Wylfa Newydd Project

Horizon's Response to Written Representation – North Anglesey Councils Partnership

PINS Reference Number: EN010007

Examination Deadline 3

Figure 5-12 a - Illustrative section on advance planting screening along the A5025

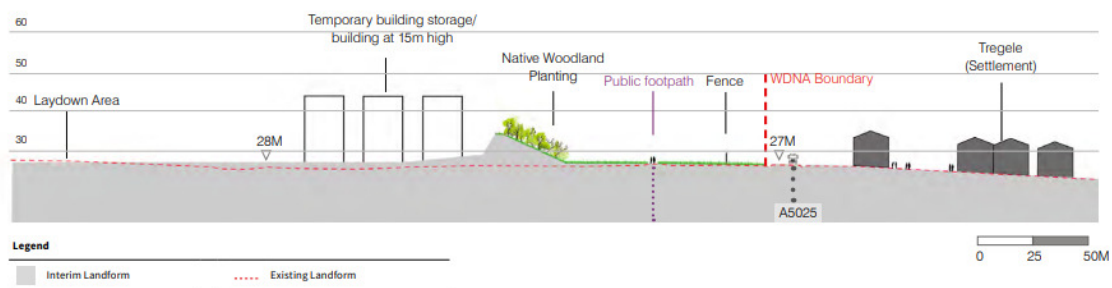
6.2.3 IACC has described part of this route as being 'sandwiched' between the A5025 and the site boundary fence during construction. This is an incorrect representation of the route, which can be seen on Figure 5-12a of the Landscape and Habitat Management Strategy ("LHMS") [REP2-039] which is shown below for ease of reference:

Figure 5-52 b - Illustrative sections of early planting during Main Construction

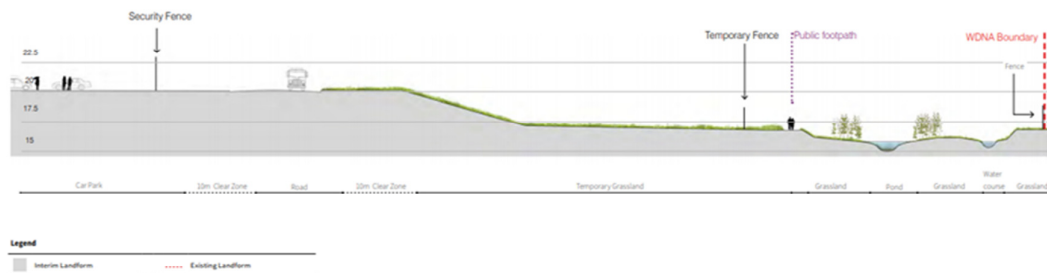
6.2.4 The diversion around the boundary of the construction site would be designed to be sympathetic to walkers, as shown on Figure 5-12b of the LHMS.

Figure 6-11 a - Illustrative section of proposed planting screening along the A5025 near Treglele

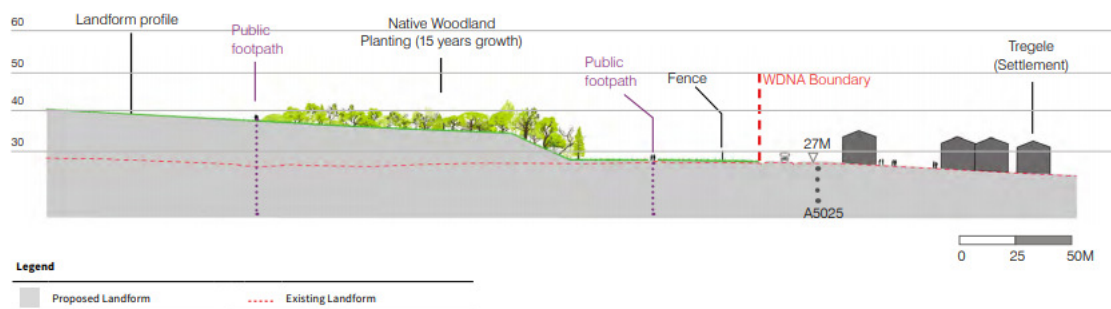
- 6.3.1 NACP has expressed disappointment that the permanent Wales Coastal Path is not proposed to be a coastal route, and that Horizon has not placed sufficient importance on the Wales Coastal Path in the restoration and landscaping proposals.
- 6.3.2 During operation, a new PRow will be provided across the WNDAs, including a route for the Wales Coast Path that is sympathetic within the new landform, and a new car park to serve Wylfa Head.
- 6.3.3 Figures 6-11a and 6-11b of the LHMS shows a section of the Wales Coast Path along the Afon Cefnau during operation:

- 6.3.4 The routing on the Wales Coast Path for operation is considered to provide a good compromise for recreational walkers, and would provide links to two car parks, one serving Wylfa Head and the other at the proposed Visitor Centre. By routing the Wales Coast Path inland this resource, which will include toilets and a café (in the proposed visitor's centre), will be an enhancement to the existing route. There would also be a nature trail, which would utilise part of the Wales Coast Path.

- 6.3.8 The argument put forward for a seaward route is that walkers would be afforded sea views. As can be seen from the above figure, sea views across the Irish Sea from the Power Station would be obscured by the MOLF and breakwater.
